Access Compliance Report Public Rights-of-Way (Curb Ramps)

Main Street: FAIRHAVEN_AVE Cross Street: YORBA_ST Location: NW

ADA ID: RPRK220126122143 Ramp Type: Type 1 - Perpendicular Diagonal Initial Pass/Fail: Fail Overall Compliance: No Severity Score: 16

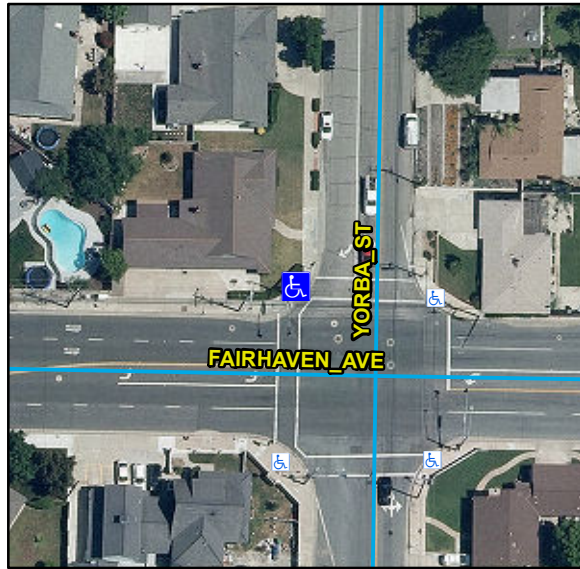
Compliance	Description	Data	Compliance	Description	Data
N/A	Ramp Length (in)	93	N/A	Flare Type LT	
Yes	Ramp Width (in)	60			N/A
No	Ramp Run Slope (%)	11.8	N/A	Flare Slope LT (%)	N/A
Yes	Ramp Cross Slope (%)	0.9	N/A	Flare Traversable LT	N/A
N/A	Landing Present	N/A	N/A	Flare Type RT	
N/A	Landing Length (in)	N/A			N/A
N/A	Landing Width (in)	N/A	N/A	Flare Slope RT (%)	N/A
N/A	Landing Run Slope (%)	N/A	N/A	Flare Traversable RT	N/A
N/A	Landing Cross Slope (%)	N/A	N/A	DWS Provided	N/A
N/A	Landing Movement Obstructed?	N/A	N/A	DWS Contrast	N/A
	Landing Movement Type	N/A	N/A	DWS Length (in)	N/A
N/A	Landing Shared	N/A	N/A	DWS Full Width	N/A
N/A	Clear Space	Yes	N/A	DWS Offset Left (in)	N/A
N/A	Clear Space To Crosswalk (in)	48	N/A	DWS Offset Right (in)	N/A
N/A	Marked Crosswalk 1	Yes	N/A	Marked Crosswalk 2	Yes
	Crossing 1 Direction	S		Crossing 2 Direction	E
	Marked Crosswalk 1 Width (in)	144		Marked Crosswalk 2 Width (in)	144

N/A	Ramp Inside Crosswalk 1	Yes	Yes	Ramp Inside Crosswalk 2	Yes
	Crossing 1 Slope (%)	5		Crossing 2 Slope (%)	6.9
	Crossing 1 Cross Slope (%)	2.4		Crossing 2 Cross Slope (%)	0.6
N/A	Gutter Ponding	N/A	N/A	Curb Slope	1.6
No	Gutter Lip Height (in)	0.5		Road Run Slope (%)	0.7
N/A	Gutter Run Slope (%)	N/A		Road Cross Slope (%)	7.3
N/A	Gutter Cross Slope (%)	N/A			
Yes	Overall Surface Condition: Acceptable		No	Perp Joint Present	No
	Cross Gutter Present?	No		Spandrel Present?	No
	Replace Cross Gutter?	N/A		Replace Spandrel?	N/A

Remove & Replace Curb Ramp With Two New Directional Ramps or Equivalent. Grind Gutter Lip.

R204.3, R304.2.2, R302.7.2, STD 1115
